## FINAL RECOMMENDATION OF THE NORTHEAST DESIGN REVIEW BOARD

Project Number: 3012547

Address: 4527 8th Ave NE (includes 4531, 4535, 4539, and 4543 8th Ave NE)

Date of Meeting: Monday, April 16, 2012

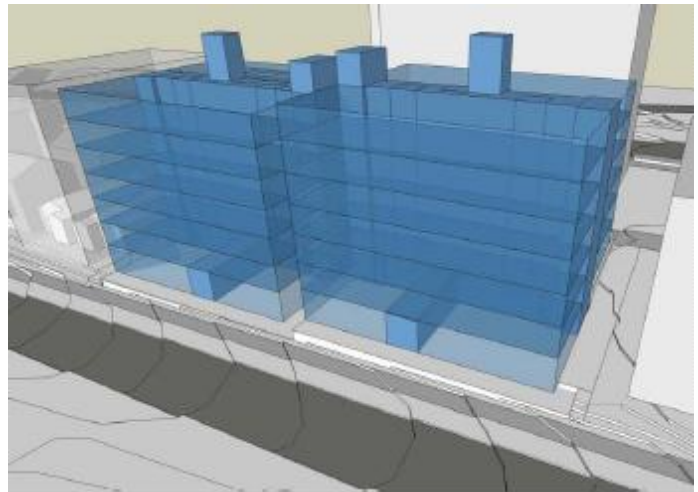
The first scheme (Option 1) showed a zoning compliant option with two buildings located over underground parking. Each building included a lobby and entrance from 8th Ave NE. A 10' separation was shown between the buildings, with setbacks that exceeded the minimum requirement at the side, front and rear property lines. This option included 154 apartments and 93 parking stalls. The applicant noted that this scheme offers an opportunity to step the buildings to respond to grade changes north to south, an opportunity to differently design the two buildings, and a large setback from the buildings across the alley. Challenges include a narrow courtyard between the two buildings, little modulation in the east facade, and the need for two lobbies and entrances.

*East facade*

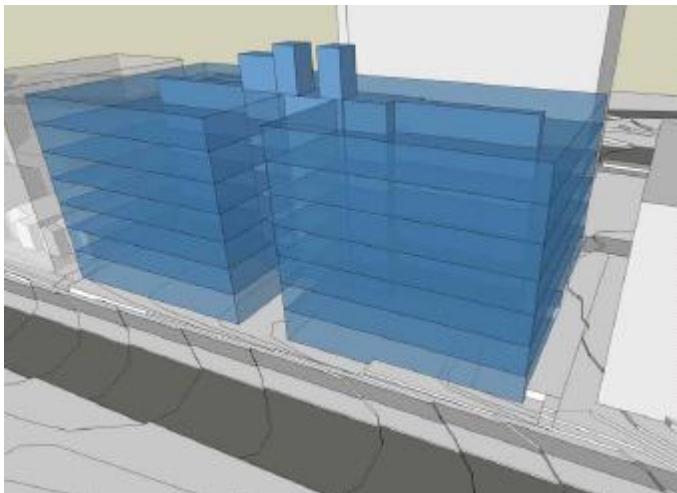
The second scheme (Option 2) showed a U-shaped building with a central courtyard facing 8th Ave NE. This option would require departures from structure width and structure depth, due to the single building and courtyard space. It would also require departures from rear and front yard setbacks since the parking structure would extend slightly above grade at the south edge of the site. This option included 164 apartments and 101 parking stalls. The applicant noted that this scheme offers a wider courtyard to create modulation, a sense of entry and gathering space; a larger front setback

than required; and an efficient single core. The massing would be similar to the Duncan Place building to the north. Challenges include a somewhat narrow courtyard and the need for departures from setbacks, structure width, and structure depth.

East facade

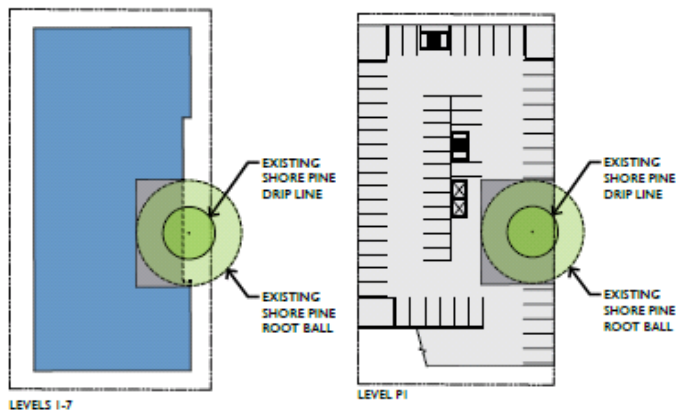
The third scheme (Option 3), and the applicant preferred option, showed a building with the front facing courtyard space rearranged to provide a wider break in the east facade, but providing less depth for a courtyard. The courtyard area at the east façade would be 15' from the property line and 4' offset from the rest of the front façade. The courtyard would be 87' wide. The departures would be similar to those required in Option 2. This option included 152 apartments and 93 parking stalls. The applicant explained that this design includes an east-facing open space that offers more light and air than the deep courtyard in Option 2, the open space responds to the park-like context across the street, the larger front setback offers the opportunity for gathering space and landscaping, and the building is lower than the maximum height. Challenges include the minimal depth of the courtyard and the need for departures from setbacks, structure width, and structure depth.
